TO: Members of the MAG Specifications and Details Committee
FROM: Robert Herz, Maricopa County DOT, Chairman
SUBJECT: MEETING NOTIFICATION AND TRANSMITTAL OF AGENDA

MEETING MINUTES FROM THE
MARICOPA ASSOCIATION OF GOVERNMENTS
STANDARD SPECIFICATIONS AND DETAILS COMMITTEE

2008 PROPOSED REVISIONS TO MAG SPECIFICATIONS AND DETAILS

DRIVEWAY WITH DETACHED SIDEWALK

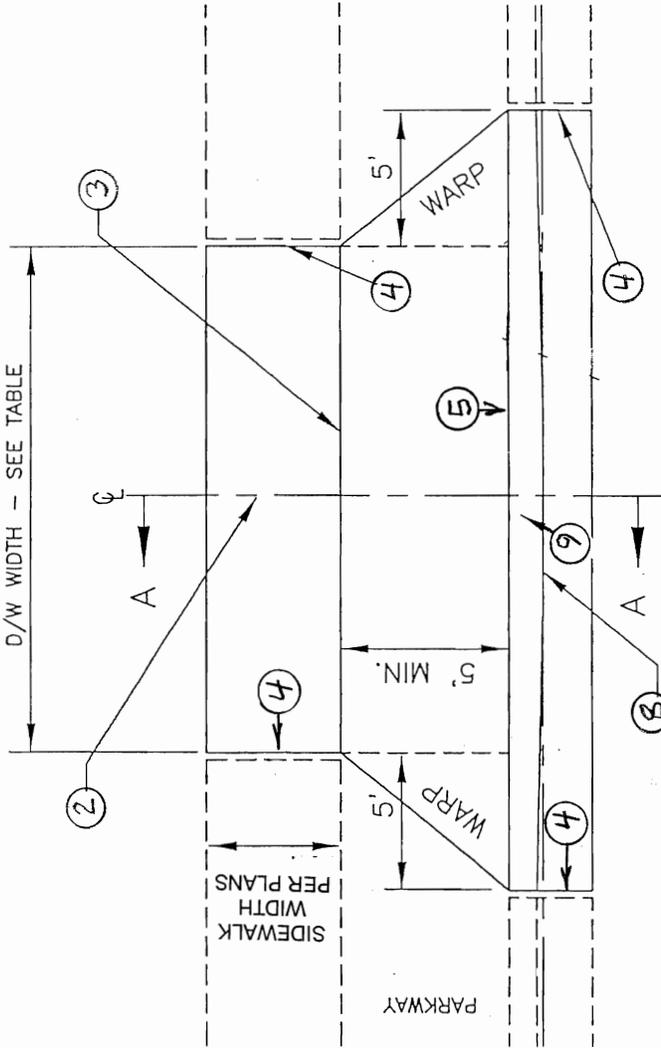
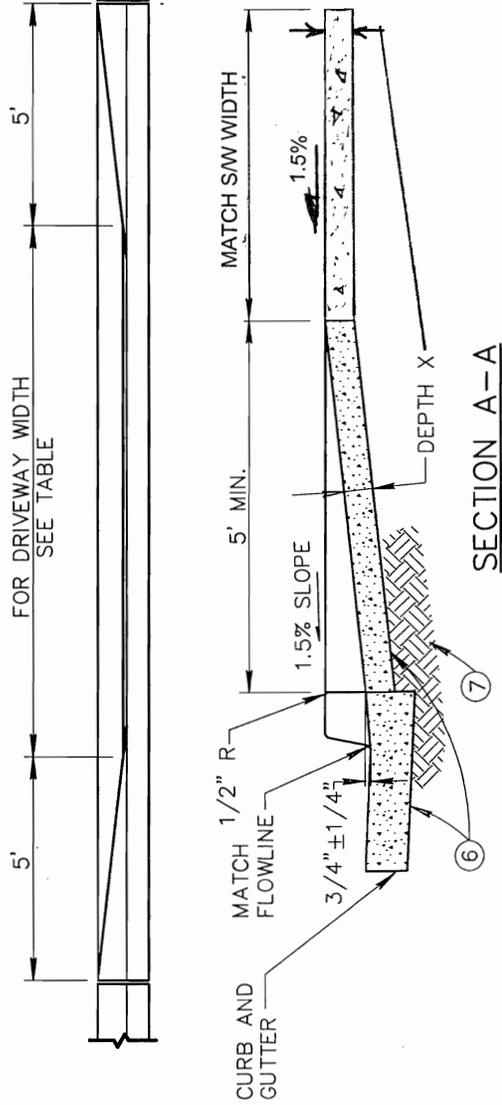
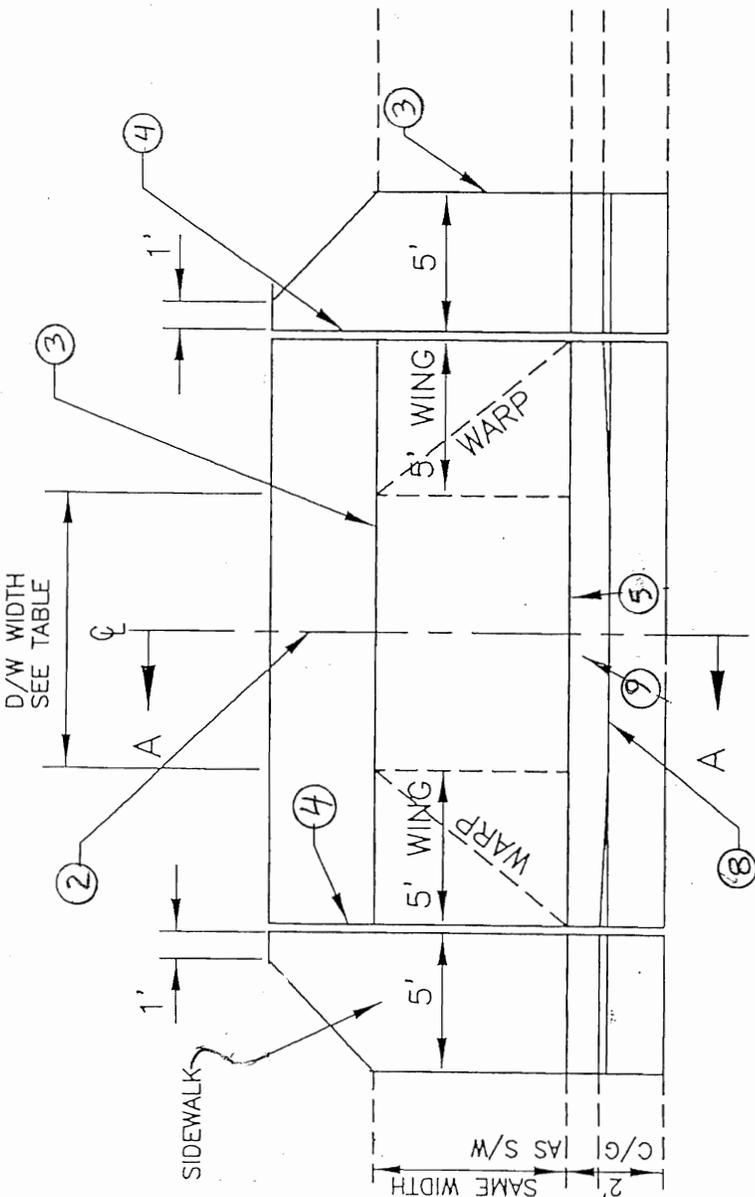
PURPOSE: Revise Detail 250 to obtain ADA compliant sidewalk installations.

REVISION: Create separate installation details for driveways when the sidewalk is detached or attached to the back of curb.
